NW Natural's Additional Revised Gasco Sediments Site Dredge and Cover Design, Implementation, Verification, and Closeout Approach Memorandum (June 3, 2019)

Re: NW Natural's Additional Revised Gasco Sediments Site Dredge and Cover Design, Implementation, Verification, and Closeout Approach

**EPA Comments on
NW Natural's Revised Gasco Sediments Site Dredge and Cover Design, Implementation,
Verification, and Closeout Approach
Gasco Sediments Site
Dated July 24, 2018**

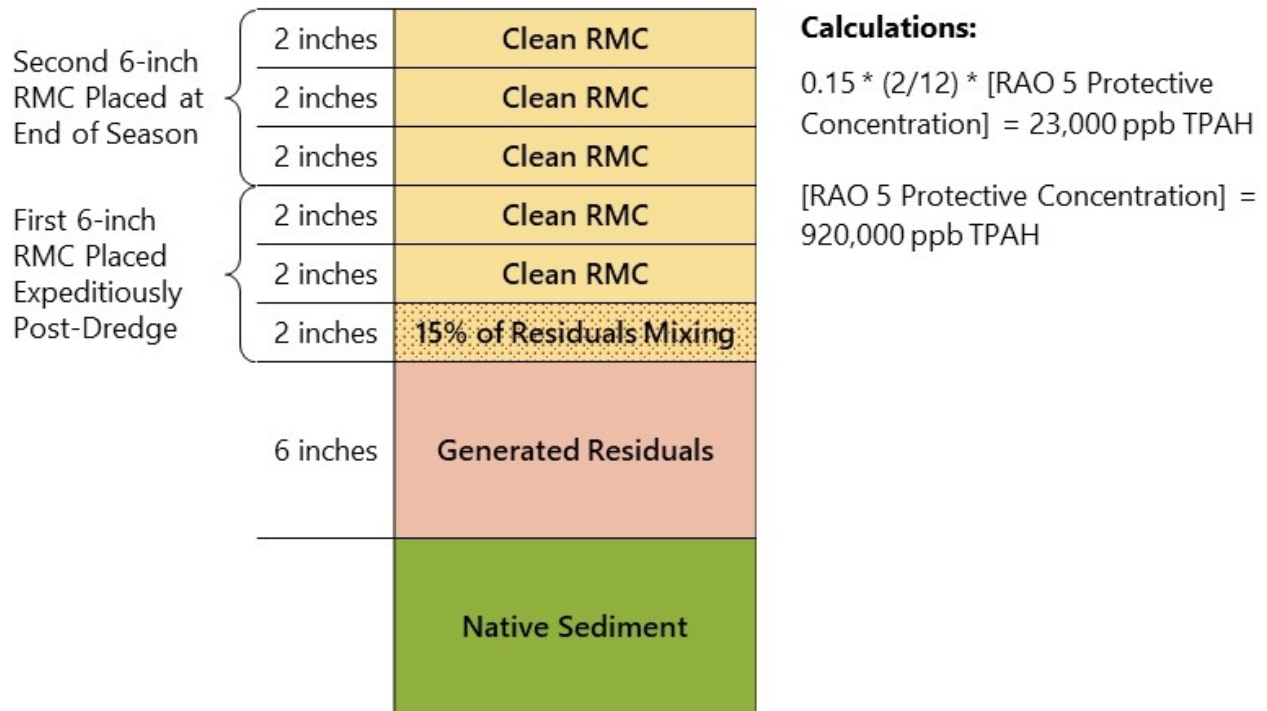
24. **Cover Verification and Closeout Approach, page 13, figure:** The figure nested in this page indicates the proposed approach anticipates generation of up to 6-inches of residuals. As discussed in previous comments, all efforts should be made to minimize generation of dredge residuals and this should be considered in future design documents.

Figure 1
Stepwise Post-Dredge and Cover Verification and Closeout Stepwise Approaches

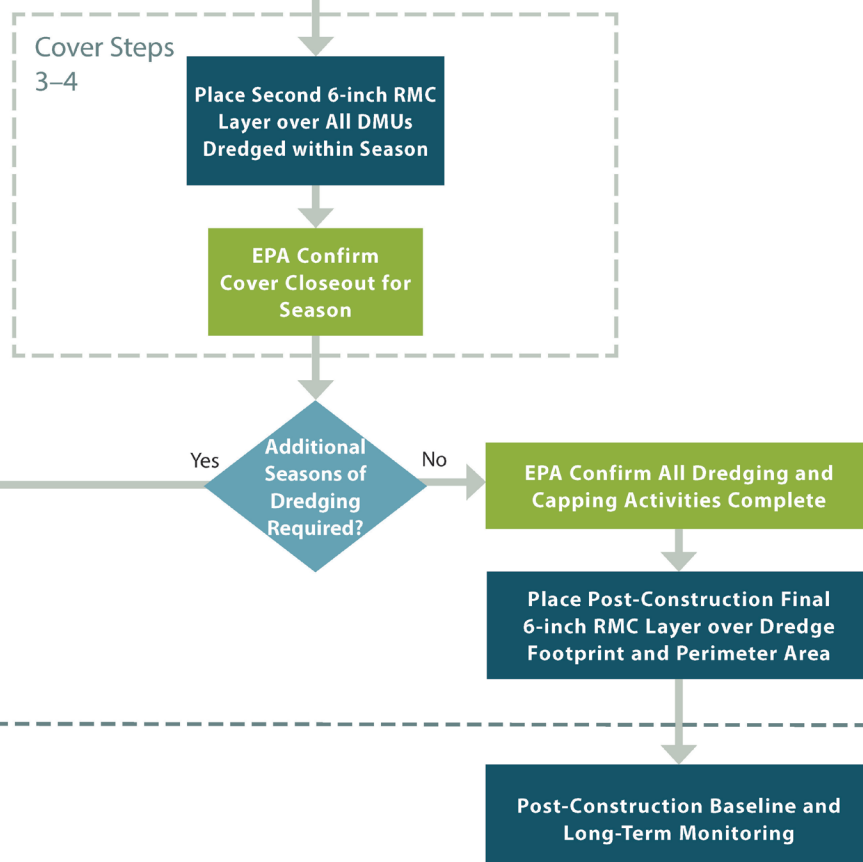
in unacceptable exposure to and migration of residuals prior to placement of the first 6-inch RMC layer. As noted in the Memorandum, specific procedures, details, and engineering evaluations for this approach will be developed for EPA approval in the remedial design documents. Further refinement of the approach should in part be based on the results of sediment sampling and analysis and the lay-out of the DMUs (sizes, numbers, depths), which are things that will be informed by the data gaps sampling work. A priority for planning the dredging work is to minimize to the maximum extent practicable the time between achieving the design elevation and placement of the initial RMC layer. NW Natural should identify realistic laboratory TATs for all analytes. If during the post-dredge evaluation process the TATs cannot be achieved, then EPA and NW Natural will evaluate the need for placement of the initial 6-inch RMC layer prior to receipt of the missing laboratory data. Additionally, the current approach will need to be made compatible with any areas where existing or data gaps sampling information indicate that TPAHs are not the primary COC and analysis of other COCs is necessitated, prolonging the analysis time. EPA requests updating the footnotes in the Figure 1 flow chart in the final Memorandum to document these contingencies.

30. **Figure 1:** The first additional measures under “Post-Dredge Step 3-5” should read “Dredge and Place 6-inch RMC Layer”.
31. **Figure 1:** The first decision point for “Cover Step 1-2” should be revised in the final Memorandum to read, “Evaluate Dredge Residuals for initial RMC Layer: PTW-NAPL Observed or RAO 5 not Achieved?”

Figure 2
Summary of Existing Riverbank and Offshore Sample Media Locations at Gasco Sediments Site

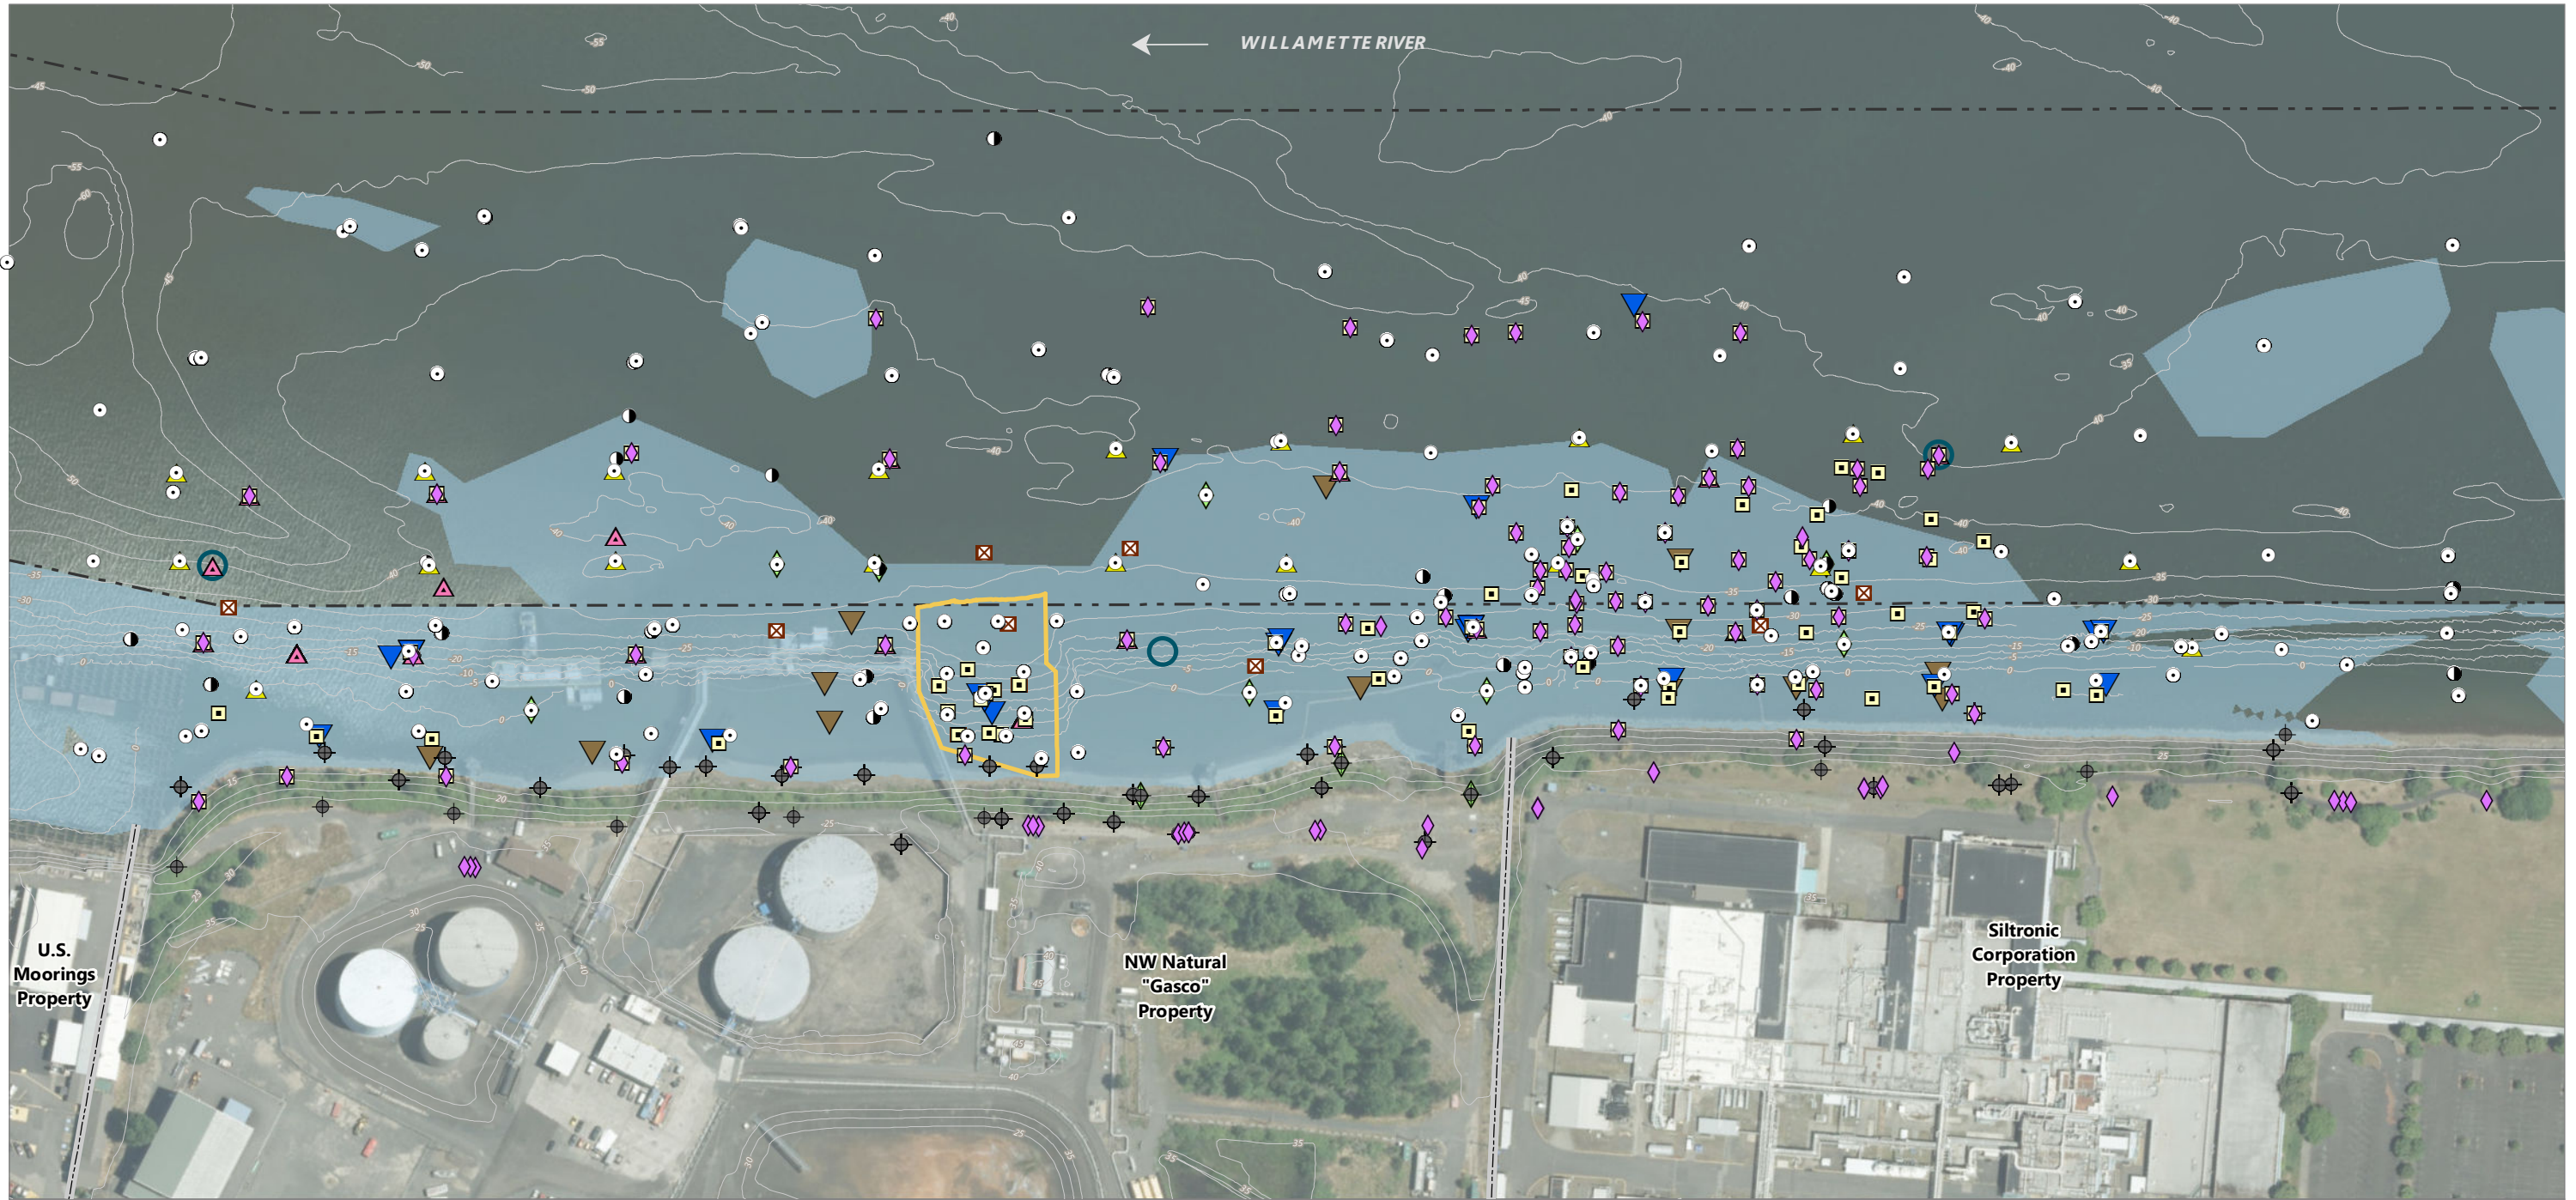
32. **Figure 2:** The Revised Post-Dredge Approach does not identify the sources and/or discuss the basis for the sampling locations shown in the figure. The Data Gaps Sampling Plan should fully document this information.
